SUBJECT: Safety Recall 04S17 – Supplement #3
 All 1999 through 2001 Model Year Taurus & Sable Vehicles
 Installation of Front Coil Spring Protective Shields for Vehicles Operated in Corrosion States

REASON FOR SUPPLEMENT #3

1999 – 2001 MODEL YEAR TAURUS AND SABLE VEHICLES — FRONT COIL SPRING PROTECTIVE SHIELD INSTALLATION

FIGURE 1

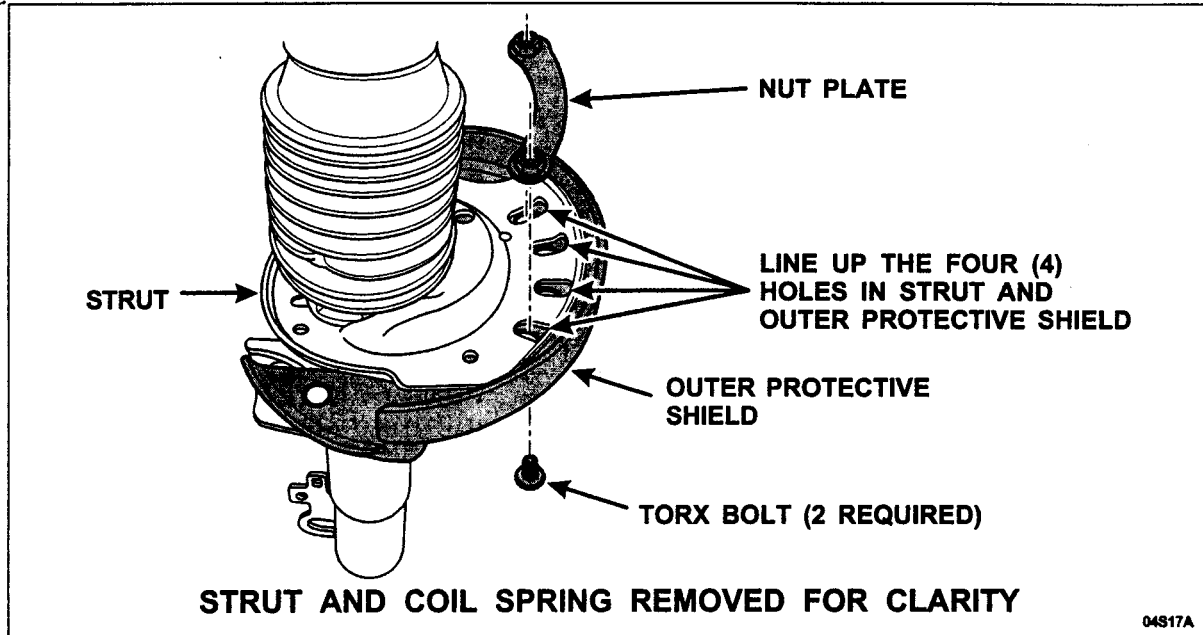
3. NOTE: Some vehicles may have had service struts installed that do not contain mounting holes to anchor the protective spring shields. Contact the Special Service Support Center at 1-800-325-5621 if you encounter any of these vehicles.

Position the outer protective shield over the strut assembly. Place the nut plate above the strut, line up the holes in the strut and the outer protective shield, and install the Torx bolts from below. DO NOT tighten the bolts to specification at this time. See Figure 1.

FIGURE 3

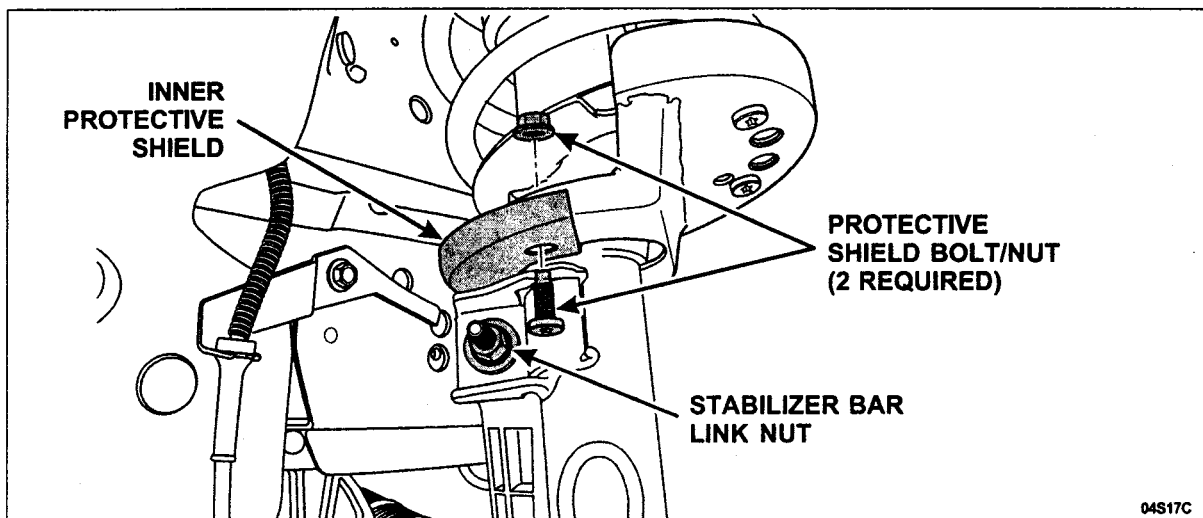
4. NOTE: When installing the stabilizer bar link nut, use the hex holding feature to keep the stabilizer bar link ball joint from turning.
 - a) Position the inner protective shield lower mounting tab behind the stabilizer bar link mounting bracket.
 - b) Before installing the stabilizer bar link, place the supplied washer over the stabilizer bar link stud. See Figure 2.
 - c) Reposition the stabilizer bar link and install *new* retainer nut. DO NOT tighten the nut at this time. See Figure 3.
5. Install the two (2) bolts and the two (2) nuts securing the inner and outer protective shields together. DO NOT tighten the nuts to specification at this time. See Figure 3.

FIGURE 4

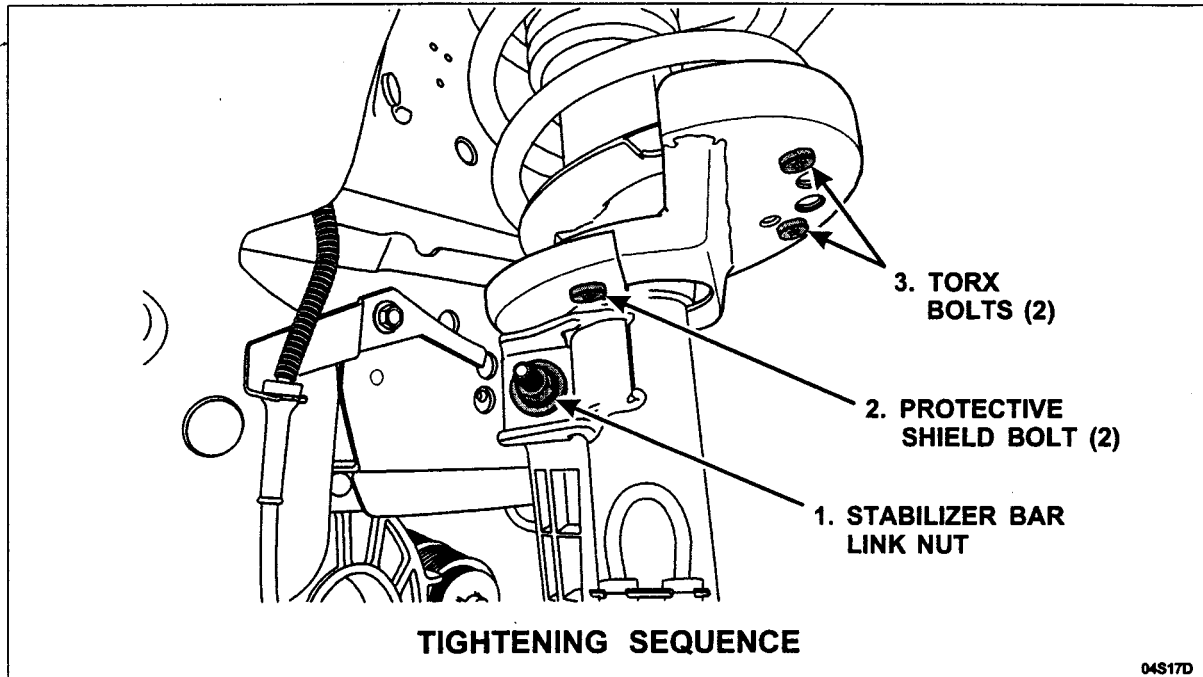
6. Tighten the fasteners in the following sequence (see Figure 4):
 1. Stabilizer bar link nuts – 90 Nm (66 lb-ft)
 2. Outer-to-inner protective shield bolts – 27 Nm (20 lb-ft)
 3. Torx bolts-to-nut plate – 27 Nm (20 lb-ft)
